ENGINE SYSTEMS, INC.

Subject: 10CFR21 Reporting of Defects and Non-Compliance -
Engine Systems, Inc. Report No. 10CFR21-0083, Rev. 0

Report No. 10CFR21-0083
Rev. 0: July 31, 2002

COMPONENT: Pistons used in EMD 645 series engines

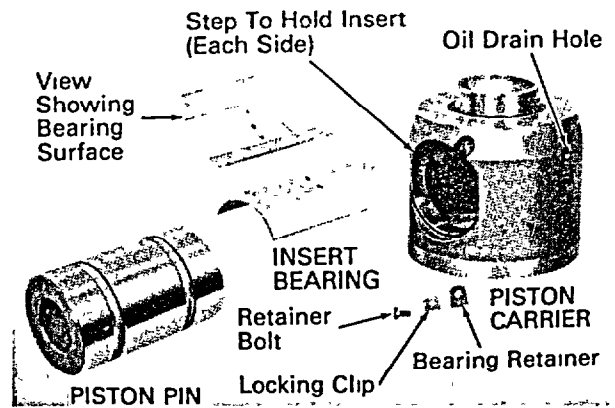
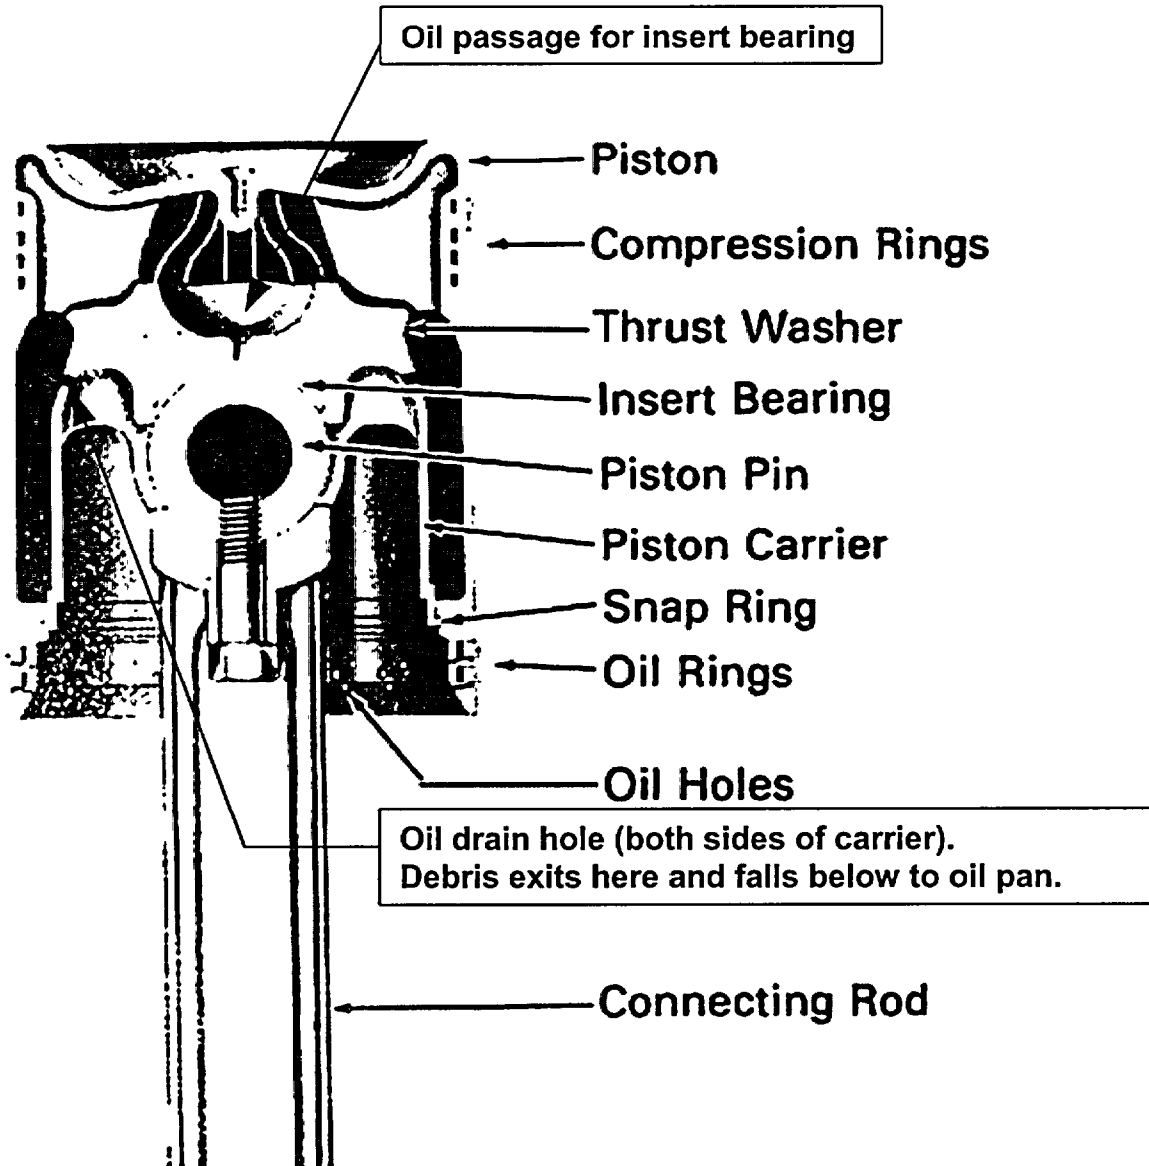
Engine Systems Inc. (ESI) has concluded our investigation of a condition reported with EMD pistons applicable to EMD 645 engines. The condition identifies casting flash material on the underside of the piston crown between the gussets (crown windows). The flash is a product of the piston manufacturing process when the piston cores are joined together. Internal parts of the piston are lubricated and cooled by the piston cooling oil. Cooling oil is directed through a drilled passage in the piston carrier and circulates about the underside of the piston crown area. Some of the oil lubricates the insert bearing and piston pin through an oil passage in the carrier and the remaining oil drains through two holes in the carrier located at the taper (refer to illustration on the next page). Any loose flash material that may become dislodged is carried by the oil through the piston carrier drain holes and settles at the bottom of the oil pan. The settled fragments are not of concern. There exists a concern, however, that a loose fragment could block the insert bearing oil passage and thus cause bearing damage. EMD has reported that no failures have been attributed to this condition (nuclear or commercial applications) to date.

EMD has evaluated this issue with their supplier. The supplier has retrained their operators, finishers and inspectors on processes and procedures relating to the pistons. ESI has also added inspections for this condition as part of the Nuclear Dedication inspections for all EMD pistons. All pistons manufactured prior to 2/21/02 are considered suspect for the flashing material condition addressed above.

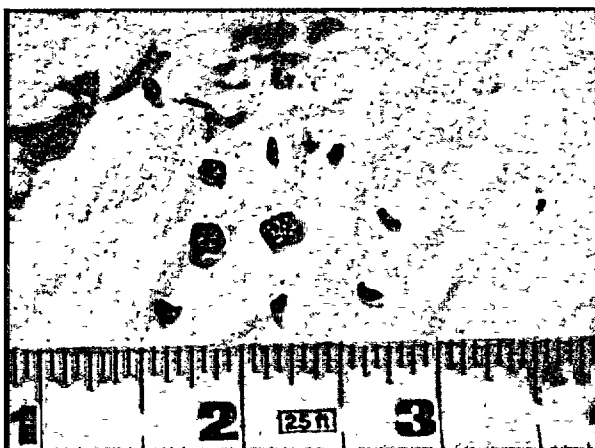
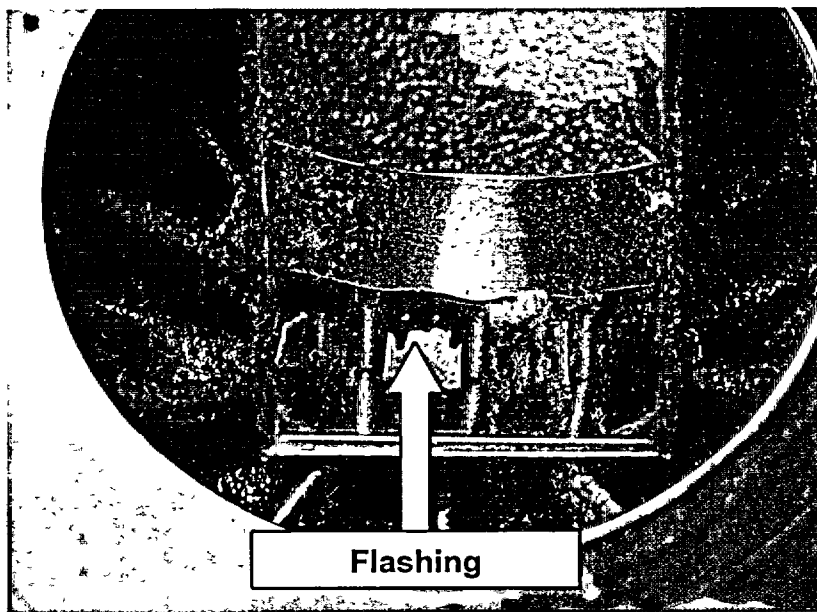
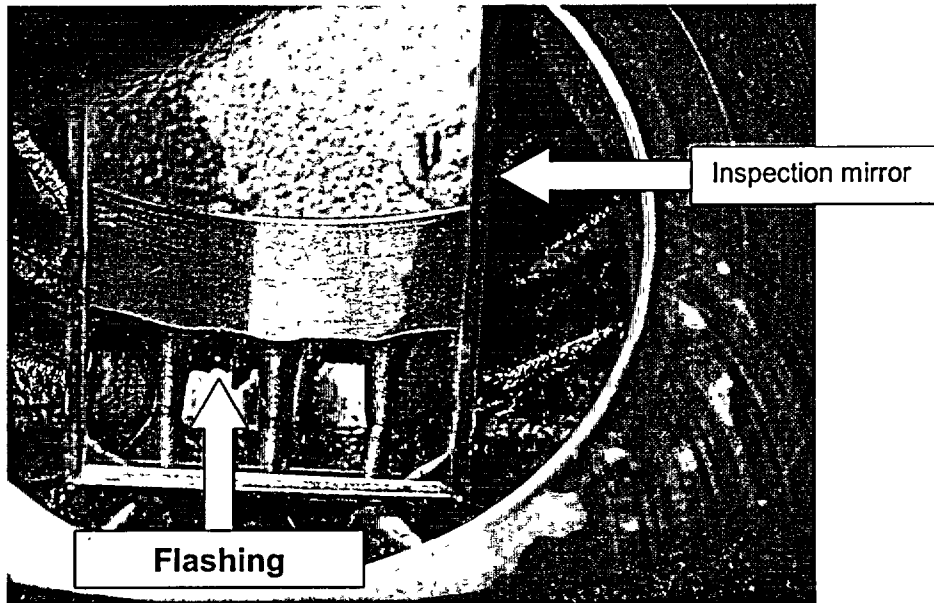
- Point Beach nuclear plant originally reported such a condition in January 2002. During maintenance activity when engine lube oil was removed, small metallic fragments (1/4" to 1/2") were recovered from the oil pan. Some of the fragments were located directly below cylinders 9 & 19. Subsequent inspection of the cylinder 9 & 19 power assemblies revealed flashing on the piston underside area near the piston crown webbing that broke away when touched by hand. The remaining 18 power assemblies were then removed for evaluation. Insert bearing inspections revealed no abnormal conditions relating to the metallic fragments. The pistons were supplied in 1999 as part of 20 complete power assemblies. 14 of the 20 assemblies had some degree of flash material with 10 of those exhibiting loose pieces that could be flaked off using a small hand tool. All pistons were identified with 1999 serial numbers. The flash condition was thought to be limited to this batch of pistons.

- During inspection of an EMD cylinder power assembly for Surry Nuclear Station, piston flashing was again noted under the piston crown. The power assembly was sent to ESI for failure analysis because of a coolant leak. The piston flashing was not related to the coolant leak issue. The Surry failure analysis was completed in May 2002. The piston was identified with a 1999 serial number. Only a partial power assembly was supplied for analysis and therefore the insert bearing was not available for evaluation at ESI.

- Recently (July 2002), Nine Mile Point reported metallic fragments in the engine oil pan. The fragments were located below 6 cylinders and resemble those found in the Point Beach engine. The pistons are identified with 1997 and 1998 serial numbers.
